The Commission has issued the enclosed Amendment No. ⁷⁹ to Facility Operating License No. DPR-59 for the James A. FitzPatrick Nuclear Power Plant. The amendment authorizes changes to the Technical Specifications in response to your request dated December 28, 1983 regarding turbine control valve modifications completed during Reload 5.

Amendment No. ⁷⁹ License No. DPR-59

ATTACHMENT TO LICENSE AMENDMENT NO. 79

SUPPORTING AMENDMENT NO. 79 TO FACILITY OPERATING

FOR ALL FUEL TYPES

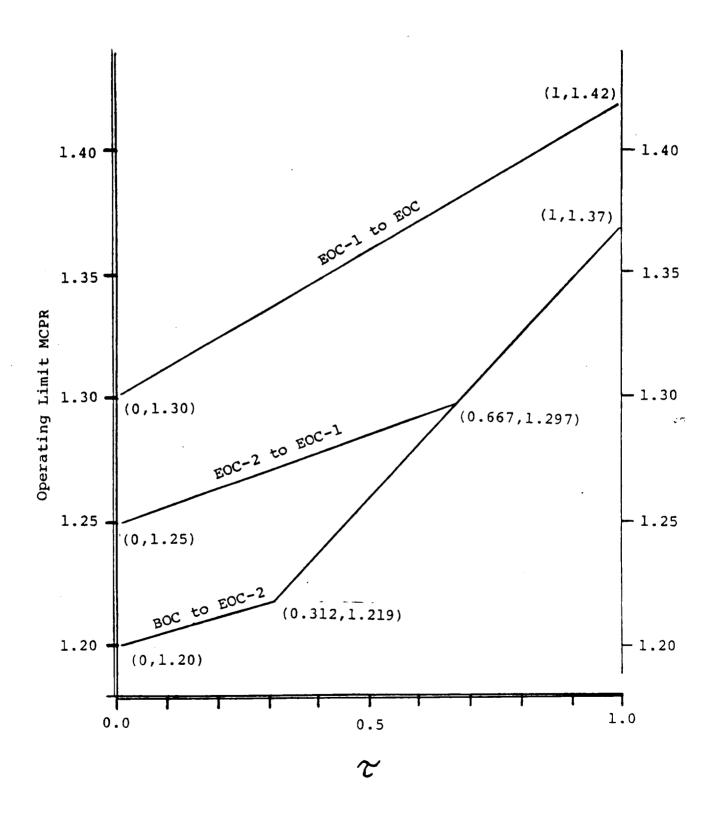
The amendment revises the minimum critical power ratio (MCPR) operating limits to restore the MCPR safety margin which was reduced as a result of changes in control valve operation. These changes resulted from valve modifications made to permit a change from partial arc to full arc turbine steam admission.

The licensee also proposed to modify Figure 3.1-2 (Operating Limit MCPR Versus - For All Fuel Types) in order to account for the turbine control valve modifications. Comparison of the revised figure to the values calculated by ODYN, show that they are consistent and, therefore, Figure 3.1-2 is acceptable.
